MCSM1-01X product update notification

October 9th, 2015

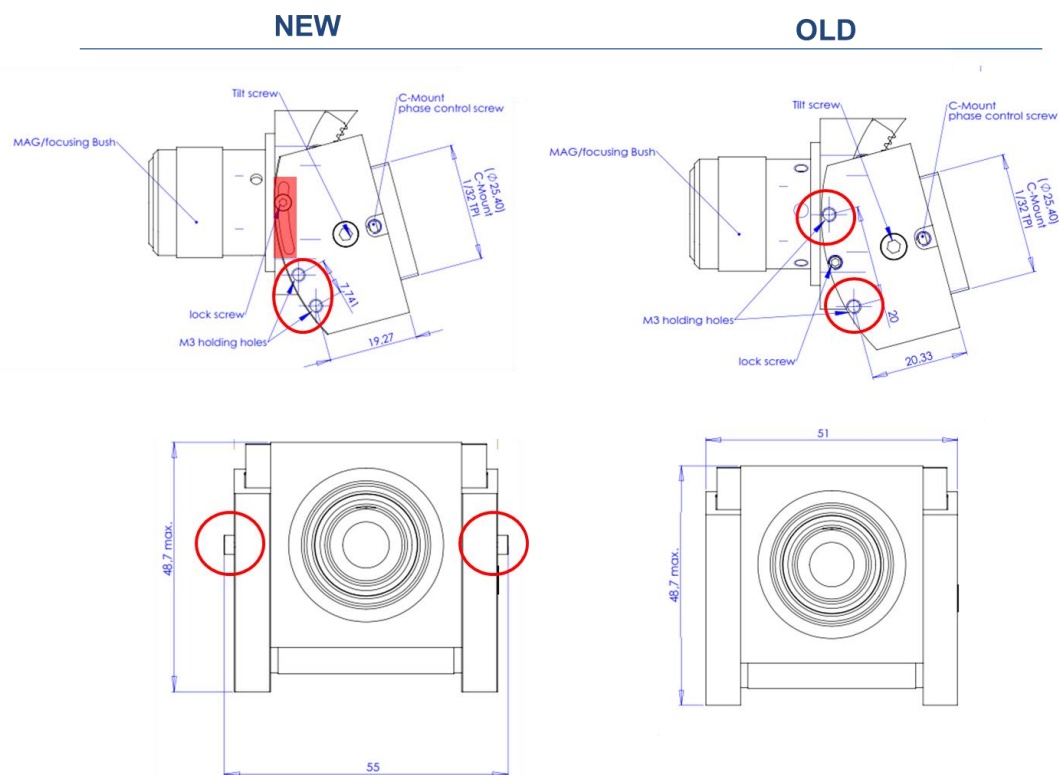
A new version of Opto Engineering MCSM1-01X has been released: it now features a more robust locking mechanism of the Scheimpflug tiltable mount.

Find differences between NEW and OLD versions here below:

1. Mechanical slots for the lock screws on both sides have been added
2. Heads of the lock screws lean out from the mechanical body in the new version
3. Positions of the lateral M3 holding holes have changed

Please check compatibility of the new version of MCSM1-01X into existing systems.
